# Hampshire County Council

## **FIRST REBUTTAL FROM JONATHAN MUNDY IN RESPECT OF HIGHWAYS AND TRANSPORTATION**

PLANNING REFERENCE P/18/1118/OA

APPEAL REFERENCE APP/A1720/W/20/3252180

Figure 1 – Linsig extract for indicative arrow model

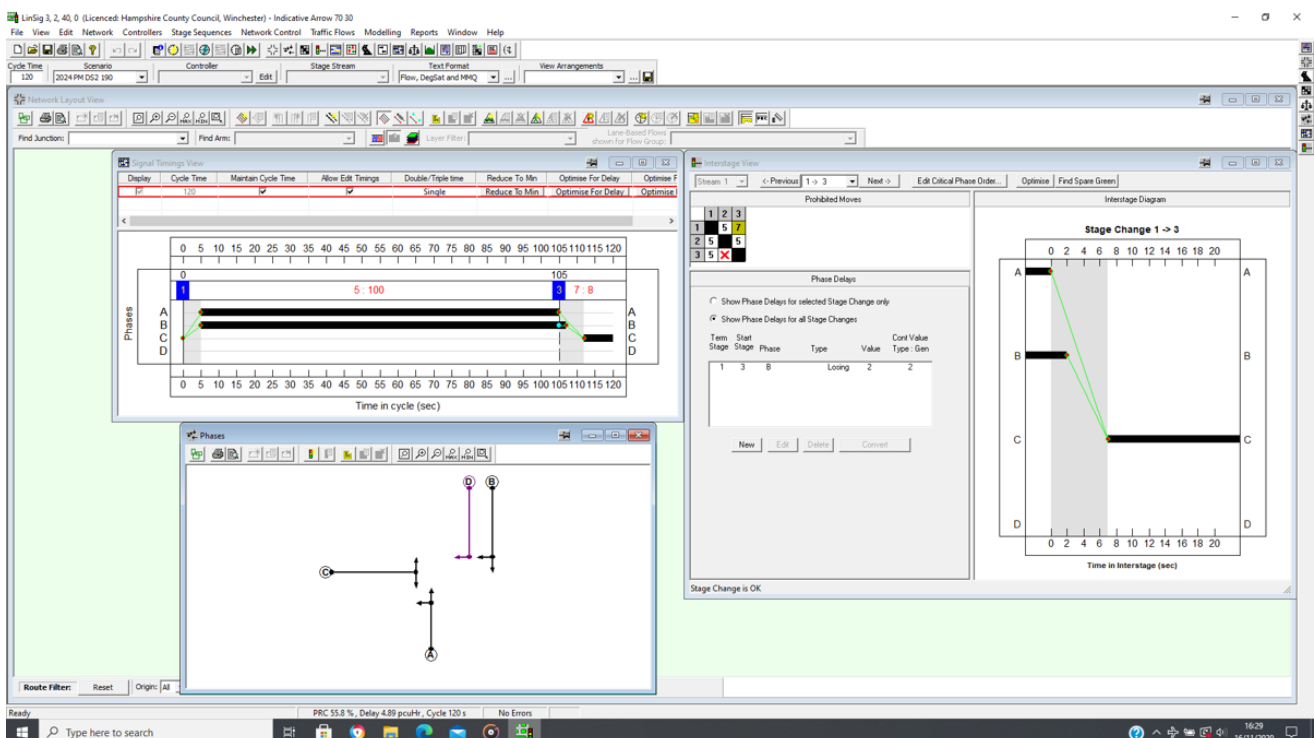
6.2 From the traffic signal Linsig model produced for the indicative option for each of the differing traffic distributions (FL&BH 3.2 Appendix F pages 87, 133, 179, 225 and 271) the 7 second duration stated above is incorrect. The duration is 5 seconds.

6.3 The model has intergreen times which are 7 seconds between phase A (Newgate Lane East northbound) and phase C (Old Newgate Lane) and 5 seconds between phase B (Newgate Lane East southbound) and phase C (Old Newgate Lane). The interstage period is 7 seconds (determined by longest phase intergreen). However the model includes a 2 second phase delay at the end of phase B (Newgate Lane East southbound) on a change from stage 1 (Newgate Lane East) to stage 3 (Old Newgate Lane). Figure 1 below shows these parameters.

6.4 The phase delay extends the appearance of the phase B green signal by a further 2 seconds beyond that of the phase A green signal. Drivers waiting in the centre of the junction to turn right in the intergreen period would seek confirmation from the secondary signal positioned in front of them. When this turns to red they would be assured that on-coming traffic would also be stopped and would start to turn when this changes to red. Effectively this provides 5 seconds in which to turn and not 7 seconds as stated.

6.5 Ms Hoskins evidence (5.26) also states that 3 vehicles could clear during the interstage period before the side road receives a green signal. The corrected 5 second intergreen period would comprise of 3 seconds leaving amber signal and 2 seconds starting red and amber signals. These are mandatory signal timings used throughout the country set in accordance with Department for Transport standards. Based on the correct 5 second intergreen period this would result in the signals being at red to all traffic for 0 seconds when changing from stage 1 (Newgate Lane East) to stage 3 (Old Newgate Lane). It is concluded that fewer than the 3 vehicles stated by Ms Hoskins could turn during this period.

6.8 As detailed in 6.3 and 6.4 of this rebuttal the stated 6 seconds period in Mr Jones' evidence (6.15) is incorrect. The time should be 5 seconds.

6.9 As detailed in 6.5 of this rebuttal Mr Jones' evidence states that 2-3 vehicles could clear before the side road receives a green. Based on the correct 5 second intergreen period it is concluded that the 3 vehicles as stated by Mr Jones would not be able to turn during this period.
